Comments of the Pacific Gas and Electric Company on the Committee Final Guidelines for Certification of Combined Heat and Power Systems Pursuant to the Waste Heat and Carbon Emissions Reduction Act, Public Utilities Code, Section 2480, et seq.

Docket No. 08-WHCE-1

2008 Rulemaking on Implementation of the

Waste Heat and Carbon Emissions Reduction Act

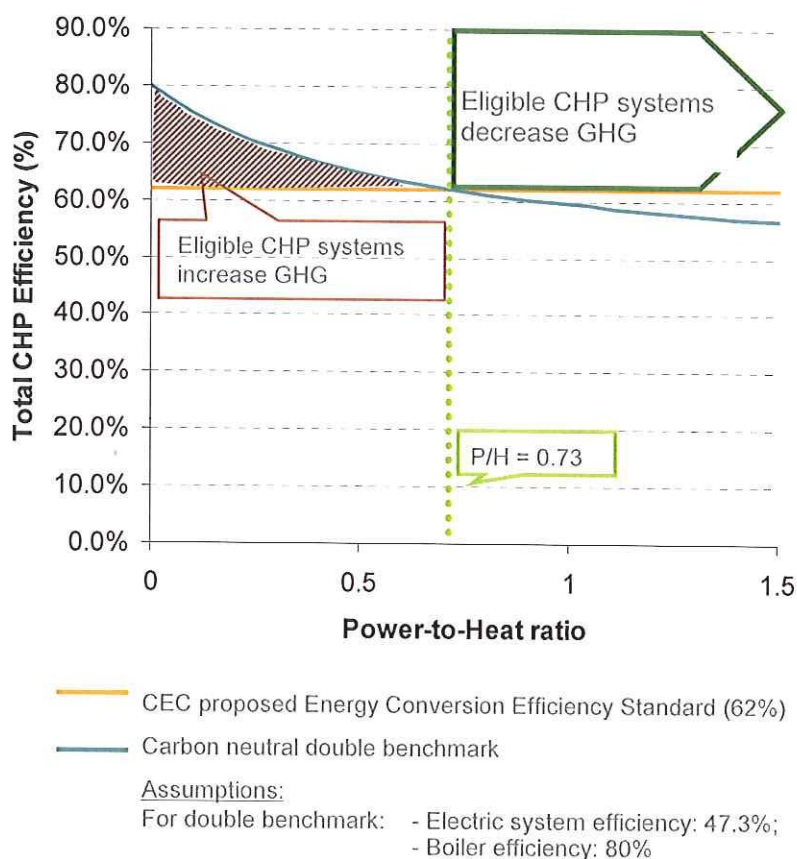
The CHP Guidelines stipulate a uniform Energy Conversion Efficiency Standard of 62 percent. Under this efficiency standard, it is possible for a CHP system to *increase* statewide GHG emissions, yet still meet the proposed efficiency standard and thus be eligible for the AB 1613 tariff. This deficiency results from the standard's failure to compare the GHG impact of CHP with the GHG impact of meeting the same energy needs through the default option of a stand-alone boiler and grid-provided electricity.

The chart below illustrates this point. The blue line labeled “carbon neutral double benchmark” shows the total efficiency a CHP system needs to attain for any given power- to-heat ratio in order to be carbon neutral, i.e. to emit the same amount of GHG as would have resulted from providing heat from an 80% efficient boiler and power from the grid.⁸ The orange line represents the 62% efficiency standard proposed by the CEC. The red shaded area indicates operating profiles where CHP systems can meet the proposed 62% efficiency standard yet actually increase GHG emissions.
